UNITED STATES PATENT AND TRADEMARK OFFICE

APPLICATION NO.	FILING DATE	FIRST NAMED INVENTOR	ATTORNEY DOCKET NO.	CONFIRMATION NO.
10/774,194	02/05/2004	Yi-Chiau Huang	AMAT/8461/CMP/ECP/RKK	6951
44257	7590	08/23/2005		
MOSER, PATTERSON & SHERIDAN, LLP APPLIED MATERIALS, INC. 3040 POST OAK BOULEVARD, SUITE 1500 HOUSTON, TX 77056			EXAMINER JEFFERSON, QUOVAUNDA	
			ART UNIT	PAPER NUMBER
			2823

Office Action Summary	Application No.	Applicant(s)	
	10/774,194	HUANG, YI-CHIAU	
	Examiner	Art Unit	
	Quovaunda Jefferson	2823

DETAILED ACTION

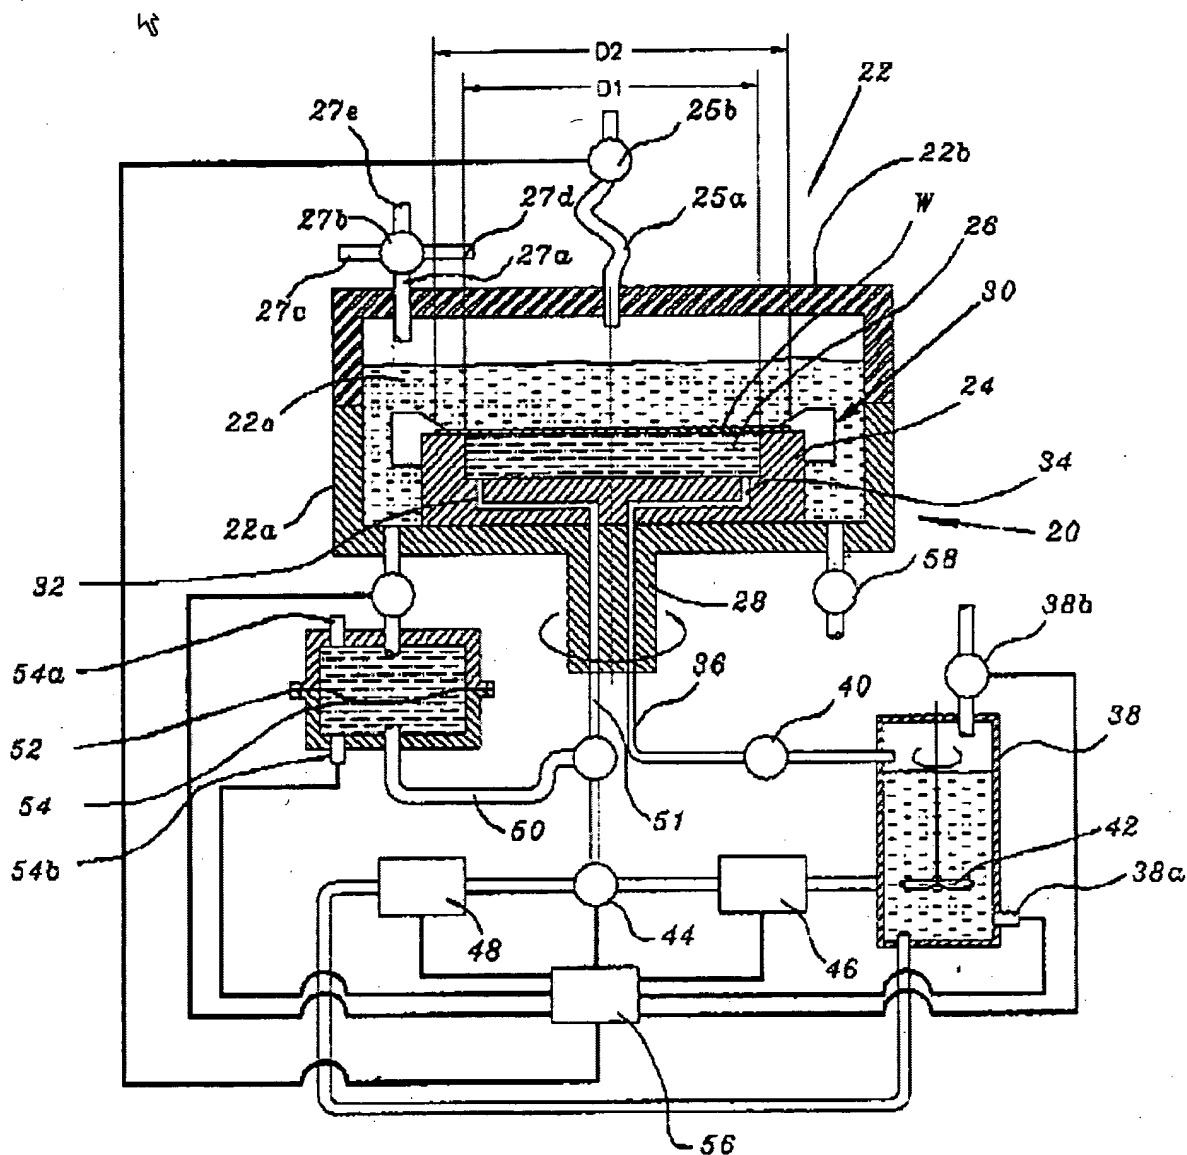
Regarding claim 15, Uzoh teach the method of claim 8, but doesn't teach further comprising controlling a temperature of a rinsing fluid to remain at a constant temperature. Ivanov teaches controlling a temperature of a rinsing fluid to remain at a constant temperature 46. It would have been obvious to one skilled in the art to combine the teachings of Uzoh and Ivanov to control the temperatures of the processes (Ivanov, paragraph 83).

Regarding claim 16, Uzoh and Ivanov teaches the method of claim 15, further comprising reading a temperature of a heated solution with a thermocouple 38a and controlling a heater positioned in communication with the rinsing solution in accordance with a temperature indicated by the thermocouple 38a.

Fig. 1

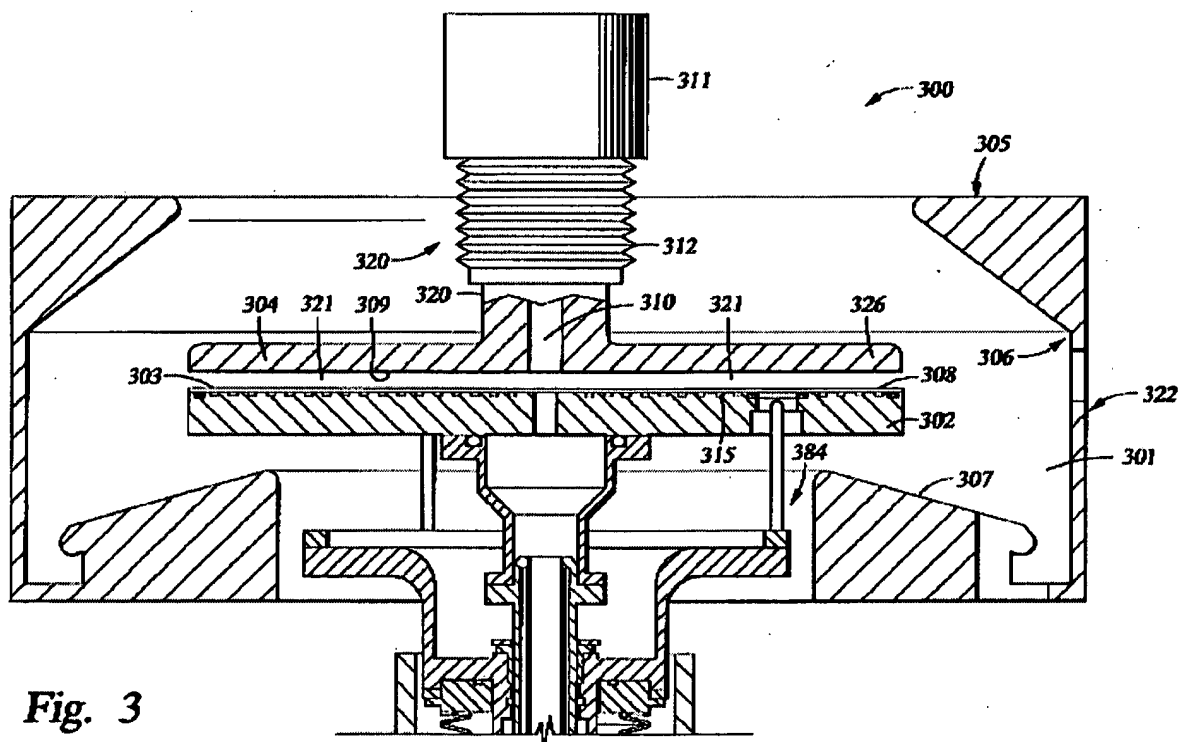
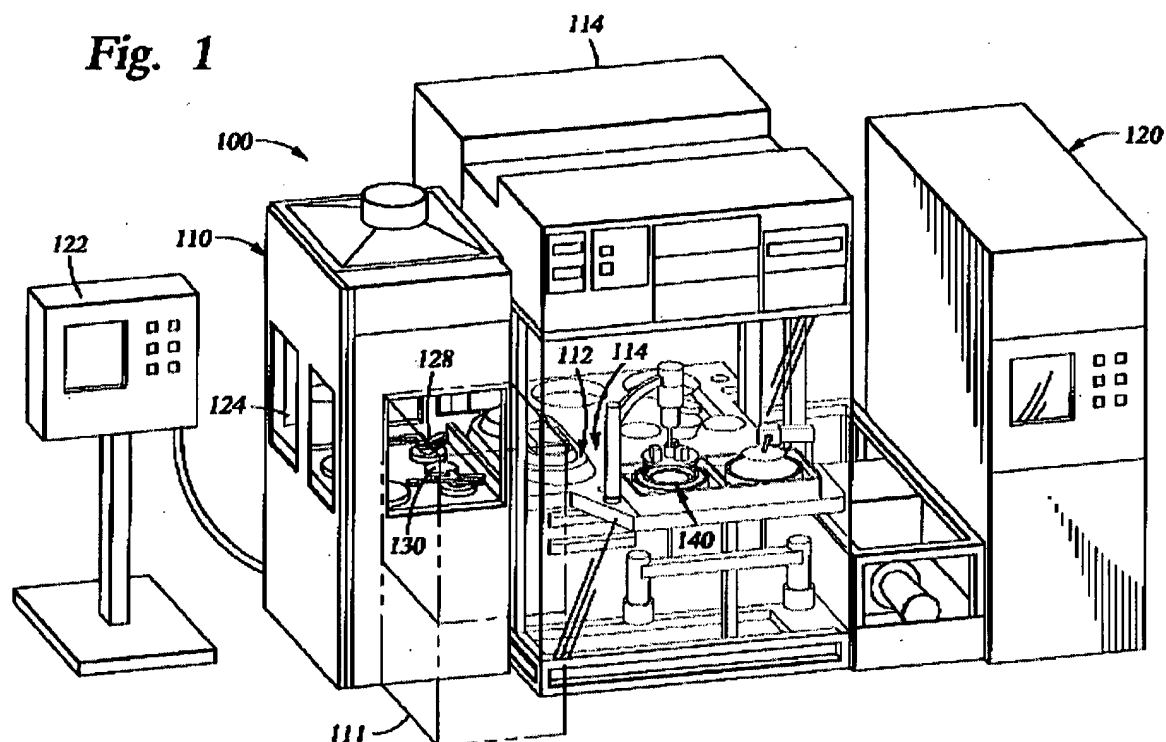
Claim 17 is rejected under 35 U.S.C. 103(a) as being unpatentable over Lubomirsky, US Patent Application Publication 2003/0131494. See figures 1 and 3 directly above. Lubomirsky teaches an apparatus for processing a substrate, comprising of a plating cell positioned on a processing platform, the plating cell being configured to plate a conductive layer onto the substrate, **figure 1-100**, a rinsing cell positioned on the processing platform, the rinsing cell comprising: a substrate support member configured to support the substrate for processing, **figure 3-302**, a fluid dispensing nozzle positioned to dispense a rinsing solution onto the substrate, **figure 3-310**, and a fluid heating assembly positioned in fluid communication with the fluid dispensing nozzle (paragraph 27), the fluid heating assembly being configured to supply a heated rinsing solution and a substrate annealing station positioned in communication with the processing platform, **figure 1-111**.

Lubomirsky does fail to teach the fluid heating assembly being configured to supply a heated rinsing solution about 50°C and about 100°C. However, given the teaching of the references, it would have been obvious to determine the optimum thickness, temperature as well as condition of delivery of the layers involved See *In re Aller, Lacey, and Hall* (10 USPQ 23 3-237) "It is not inventive to discover optimum or workable ranges by routine experimentation. Note that the specification contains no disclosure of ether the critical nature of the claimed ranges or any unexpected results arising therefrom. Where patentability is said to be based upon particular chosen
